CERTIFICATE OF APPROPRIATENESS

Property: 3405 Piping Rock Lane, Lot 9, Block 60, River Oaks Subdivision. The property includes a historic 4,591 square foot, two-story painted brick & stucco single-family residence and a detached garage situated on a 15,299 square foot (103' 6" x 150') corner lot.

Proposal: Alteration – Addition, Attached Garage, and Front Façade Alteration

North Elevation – Proposed

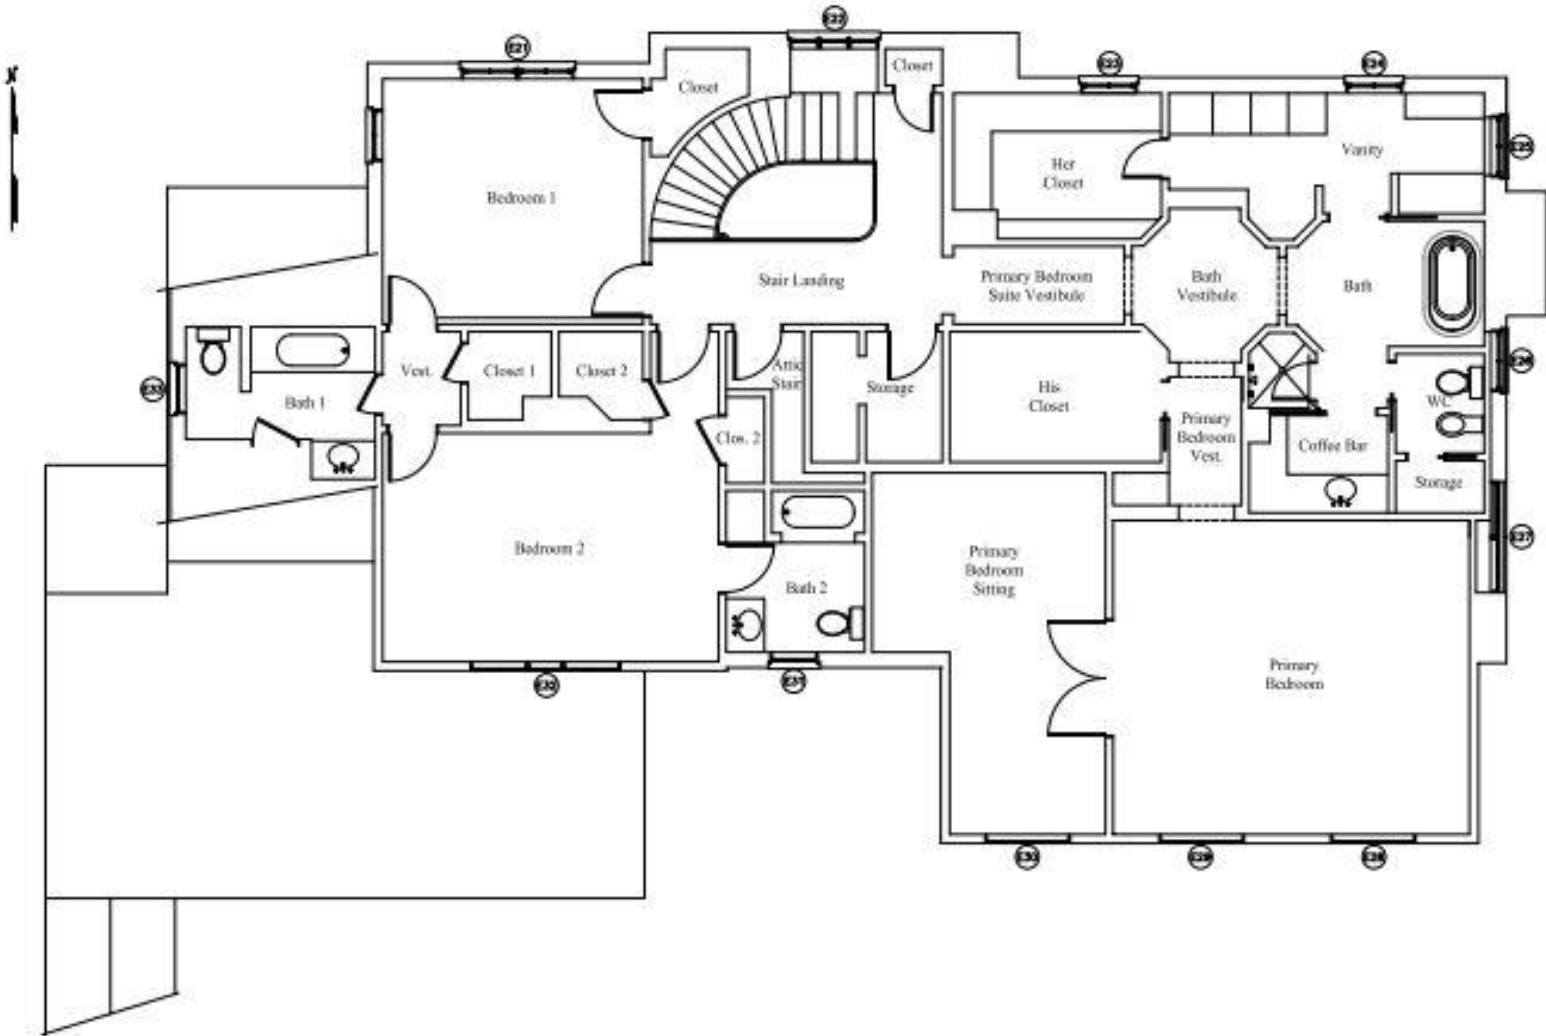
- Re-clad existing second-floor, original stucco front (north) gable with painted brick
- Replace existing front door with a new mahogany door

| | <input checked="" type="checkbox"/> | <input type="checkbox"/> | (1) The proposed activity must retain and preserve the historical character of the property; <i>The existing, original stucco on second-floor front (north) façade is part of the historical character of the property.</i> |
| <input type="checkbox"/> | <input checked="" type="checkbox"/> | <input type="checkbox"/> | (4) The proposed activity must preserve the distinguishing qualities or character of the building, structure, object or site and its environment; <i>The existing, original stucco on second-floor front (north) façade is part of the distinguishing quality of historical character of the property.</i> |

| <p>Recommendation: Approval with conditions: Retain existing, original stucco on second-floor front (north) facade</p> <p>HAHC Action: -</p> |
